CITY OF GLENDALE, CA

DESIGN REVIEW STAFF REPORT – SINGLE FAMILY

1621 Cleveland Road

PADR-000927-2023

Proposed North Elevation

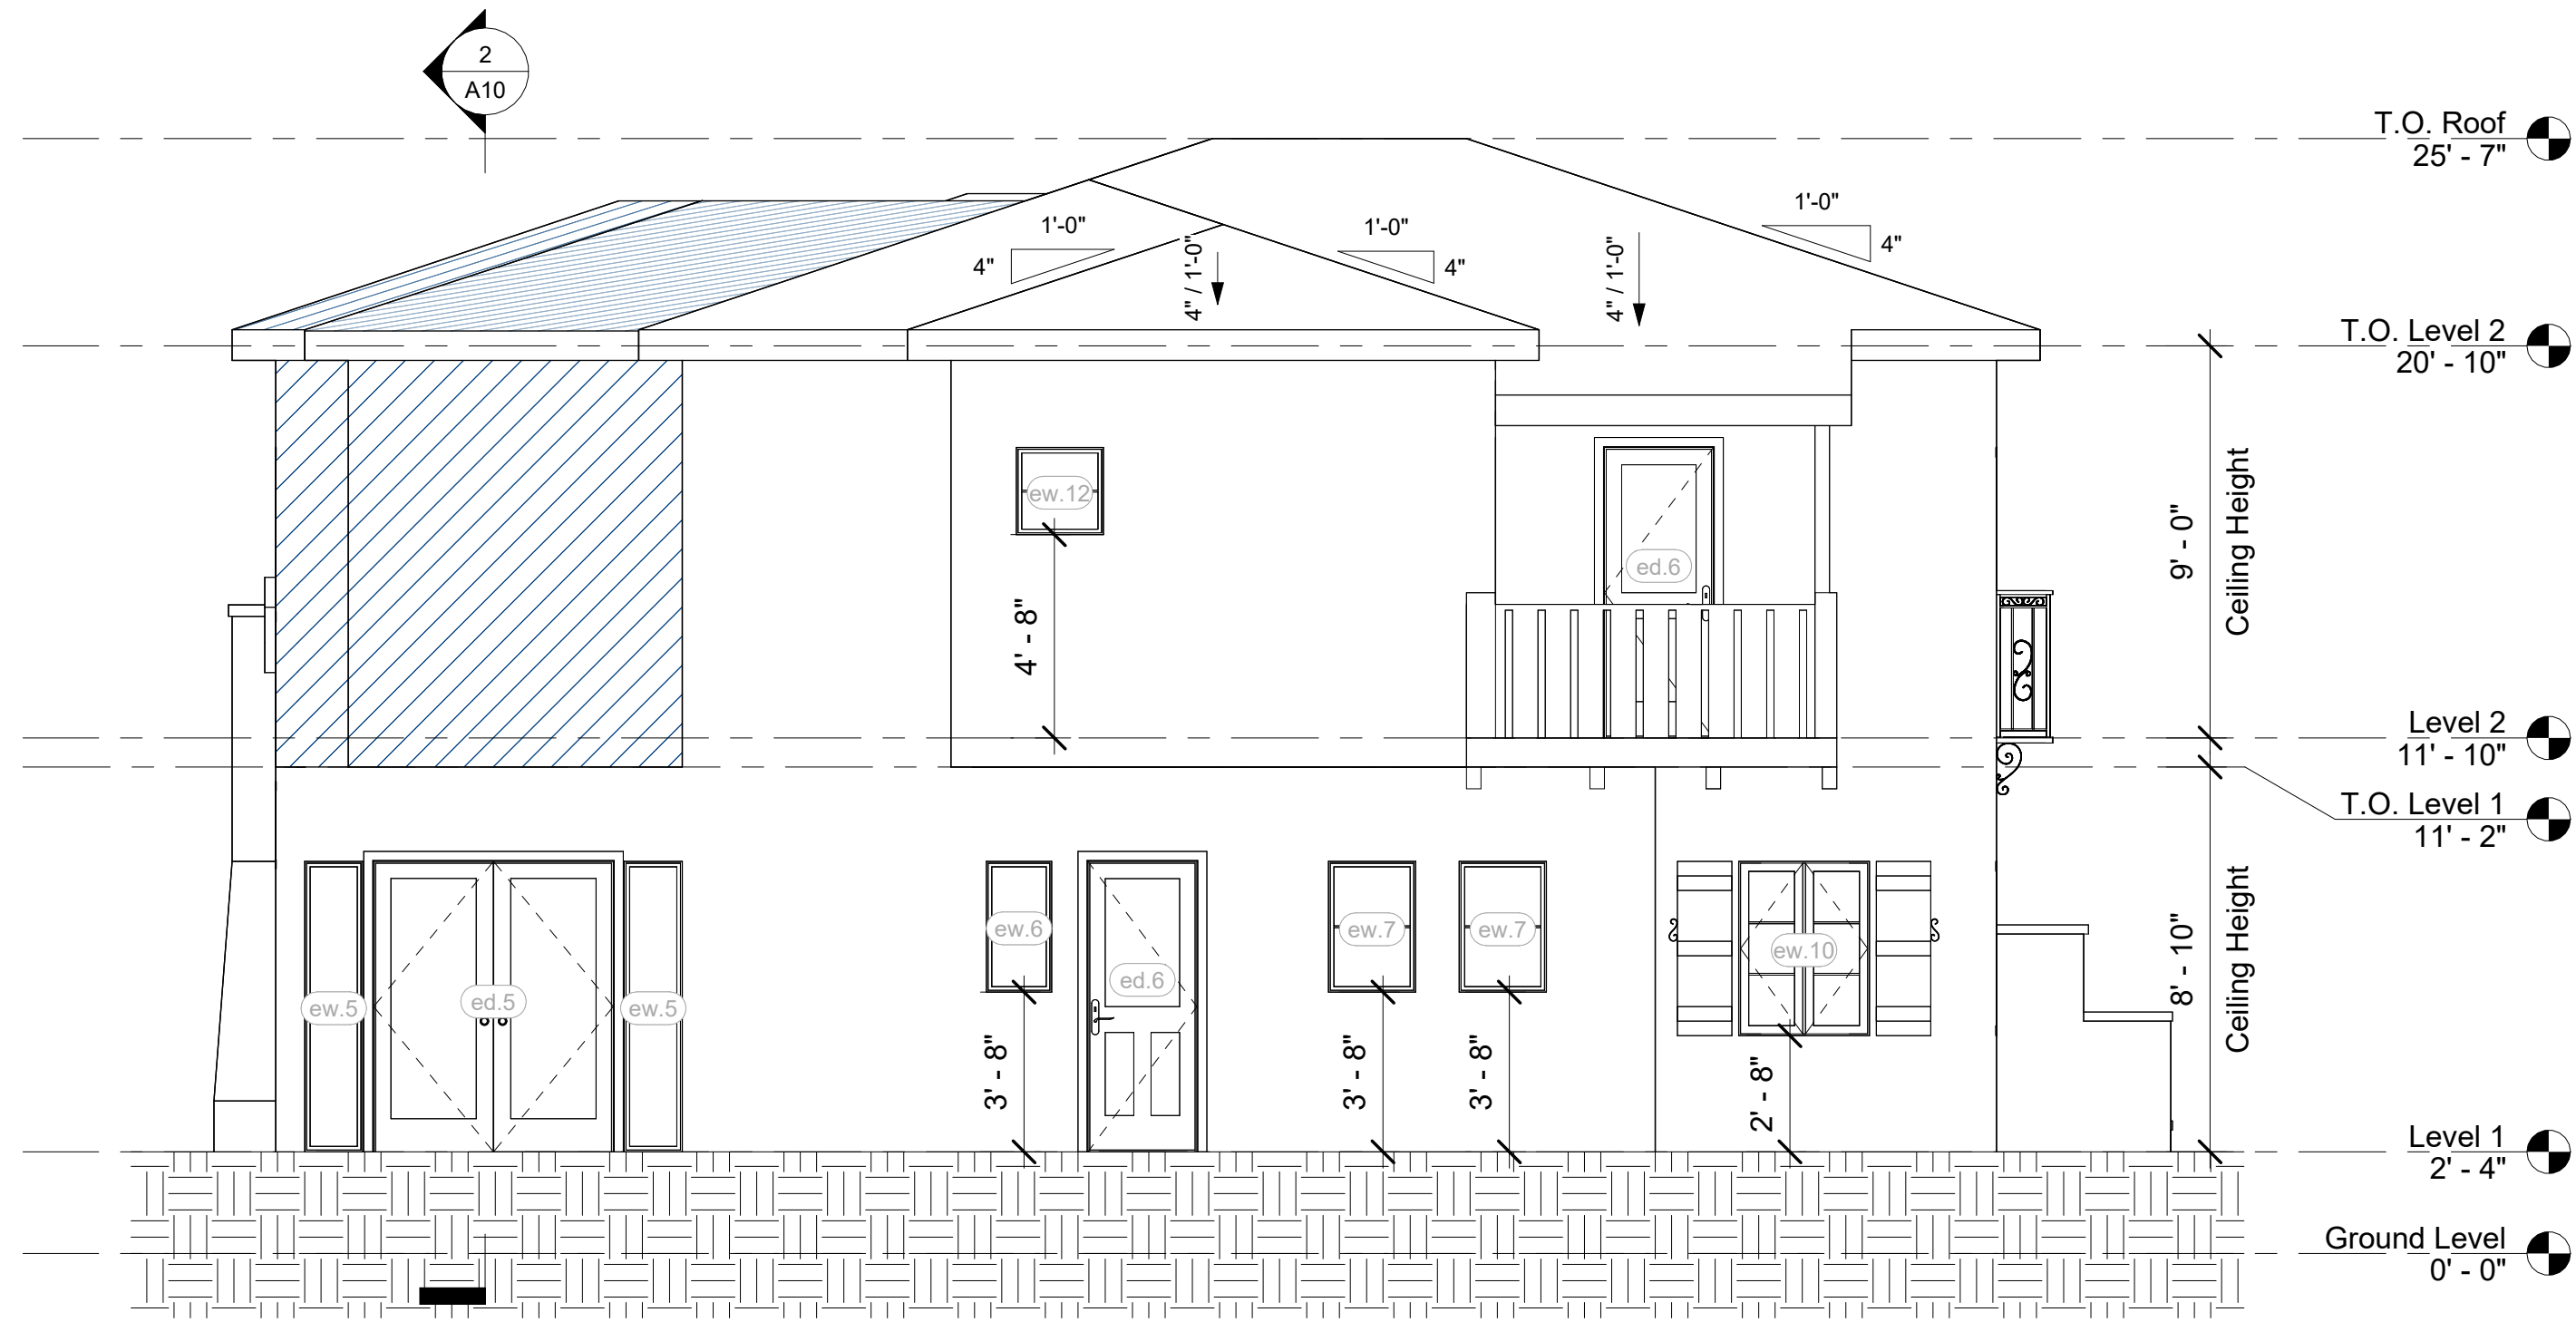
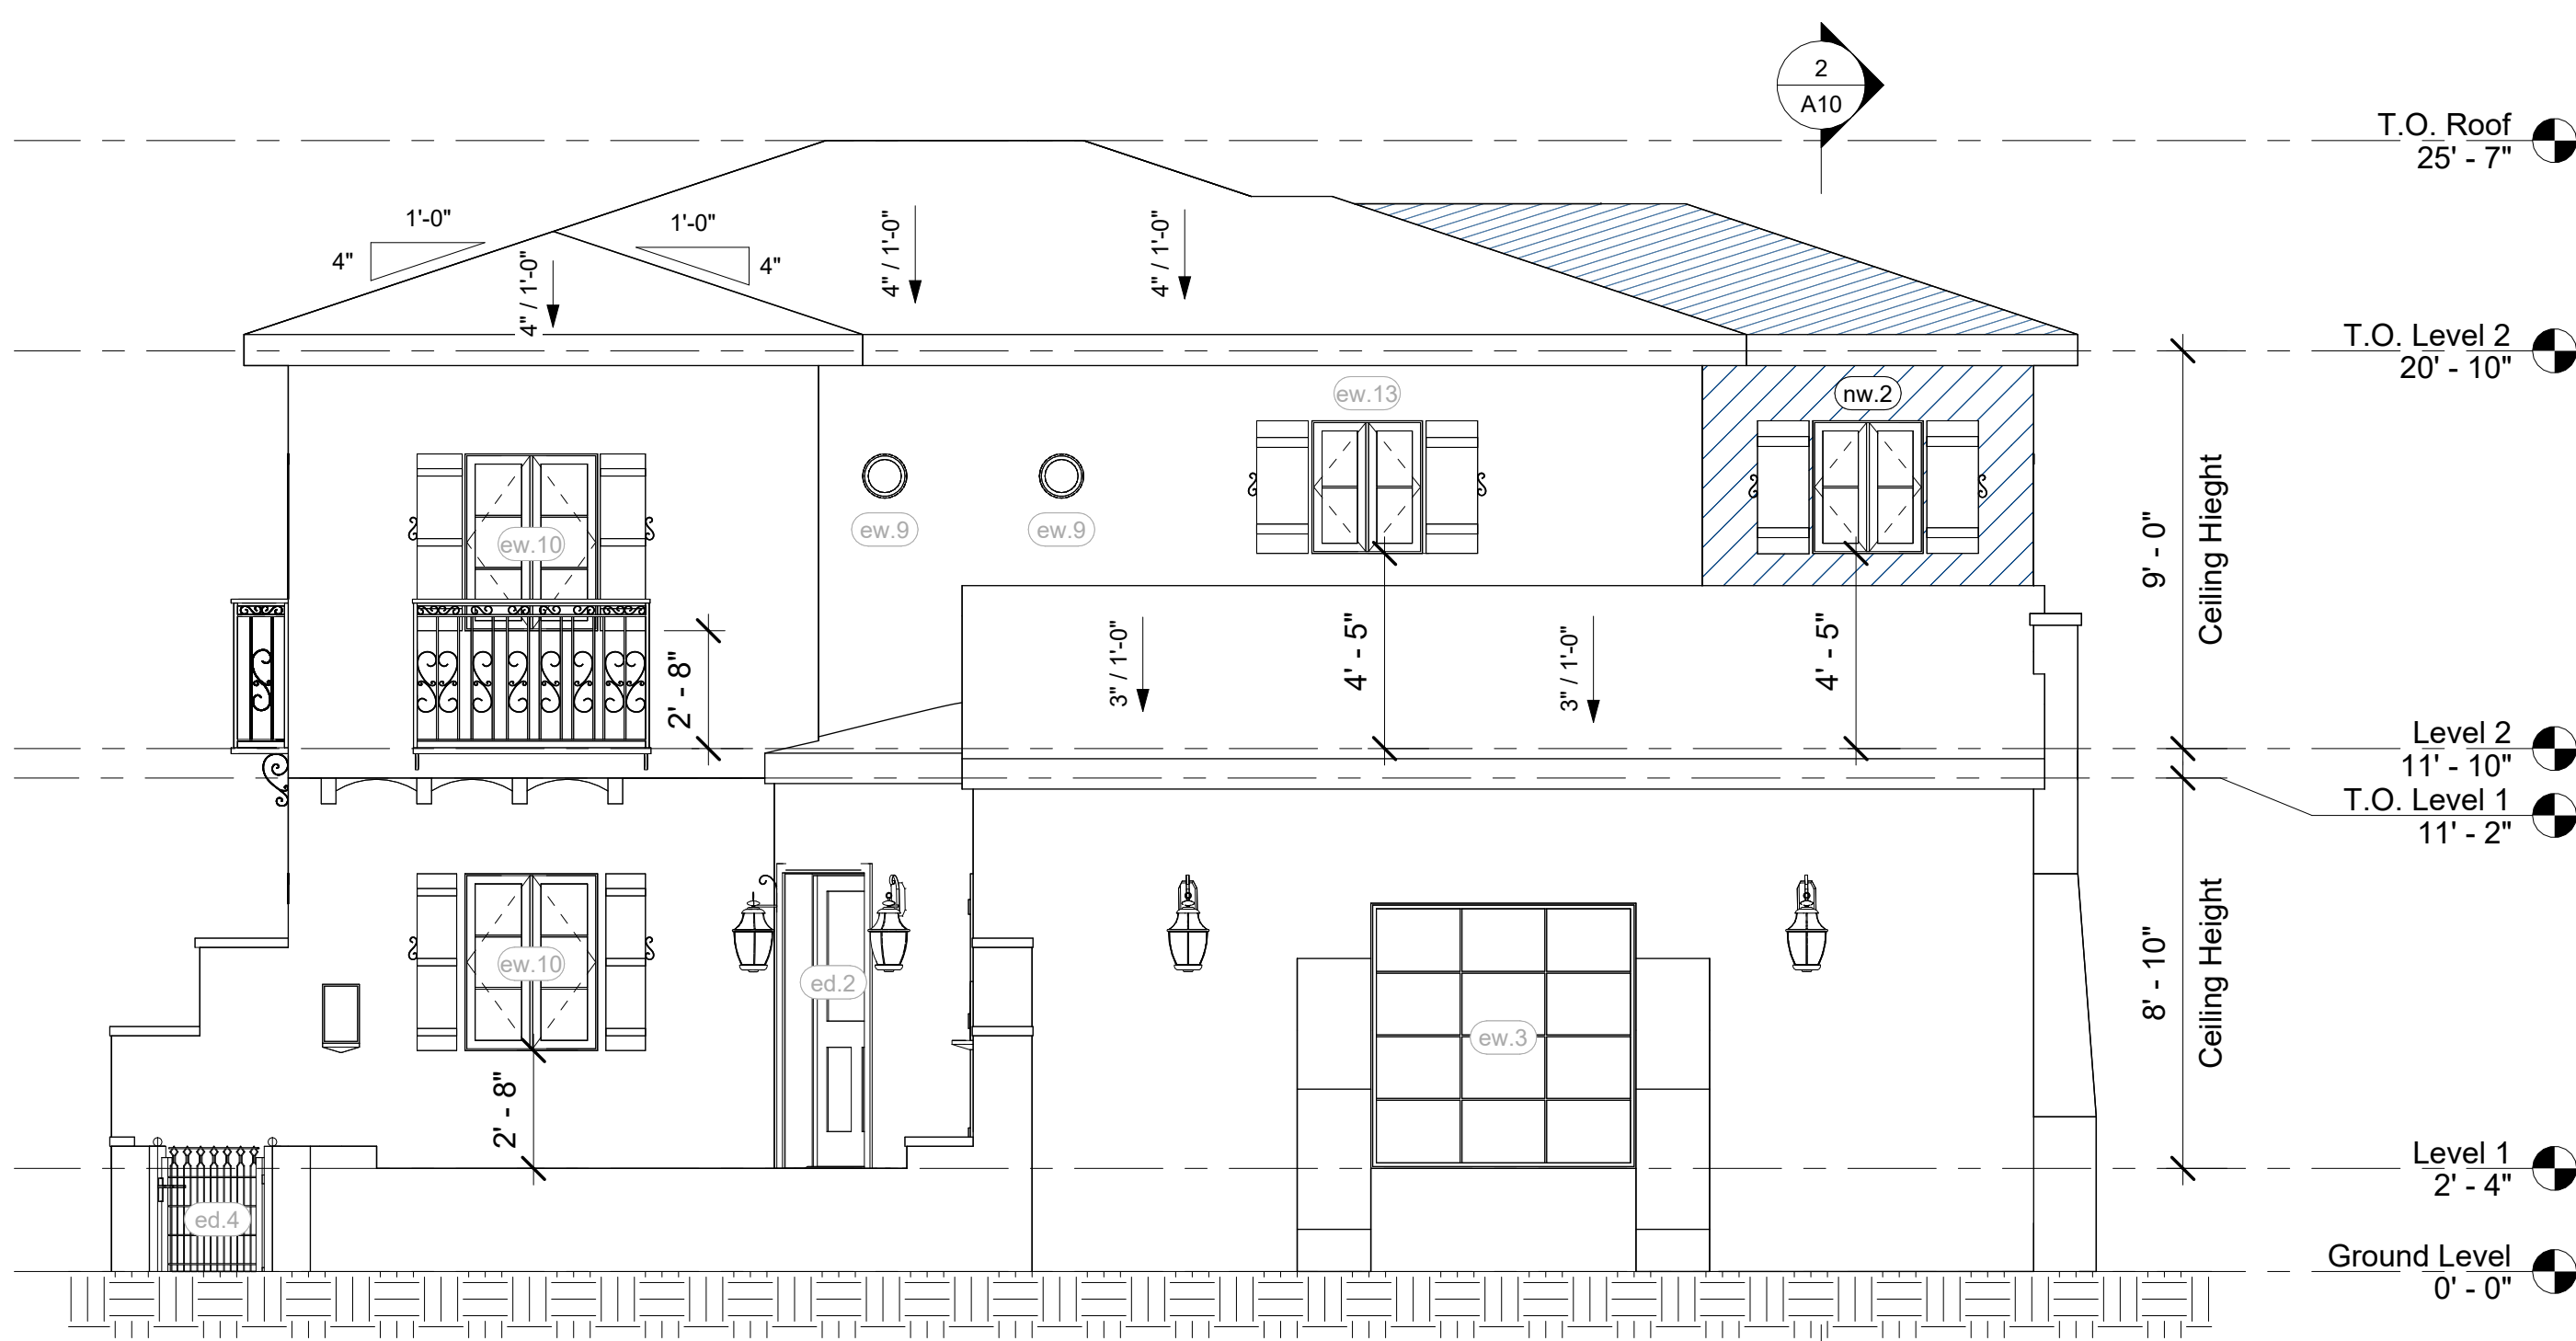
The new second story mass is also stepped in from the original corner of the primary façade and is located behind the existing one-story projection of the front façade. This helps minimize the feel of additional massing on the primary façade.

The new hipped roof form is compatible to the existing hipped roof form, is stepped back from the existing front façade to create differential between the two and is slightly lower in height than the existing to minimize its impact.

Proposed East Elevation

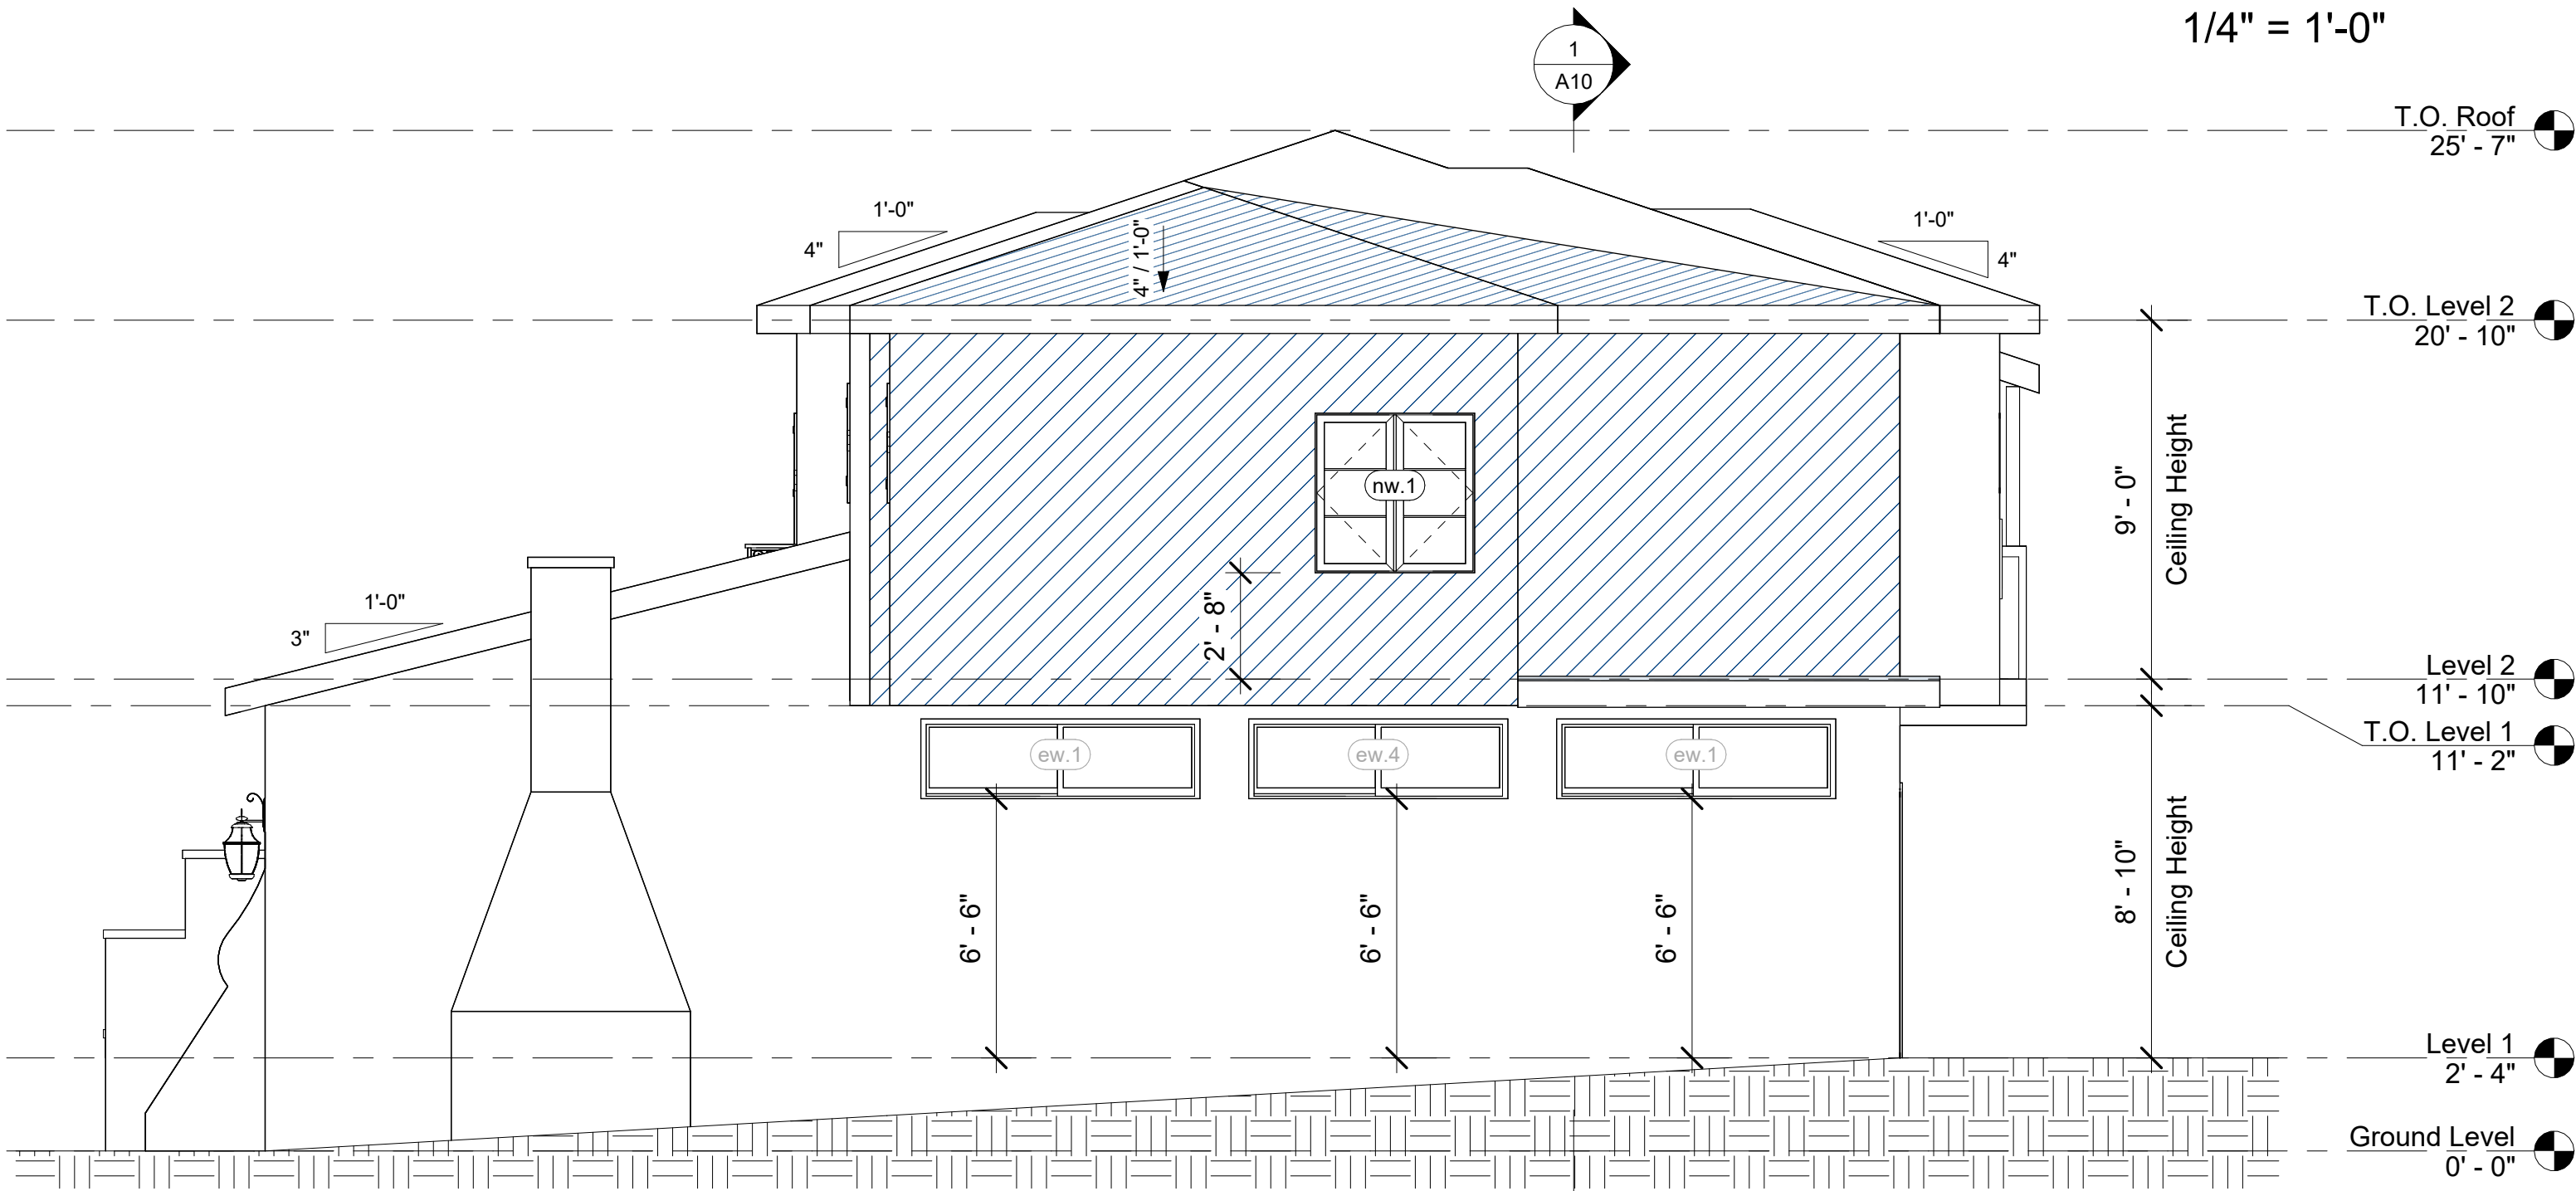
The addition is minimal in size and is appropriate to the surrounding context. The adjacent property to the east is a one and two-story building. Though the one-story massing of the adjacent building is closer to the project site, the retention of the existing setbacks and the step in of the proposed addition along the front façade minimizes its impact.

- The single-family residence could be returned to its original size and shape in the future. The walls at the east façade and original one-story roof below would require reconstruction, but the simple design of the existing, which are documented in this application, would allow for a faithful replication.
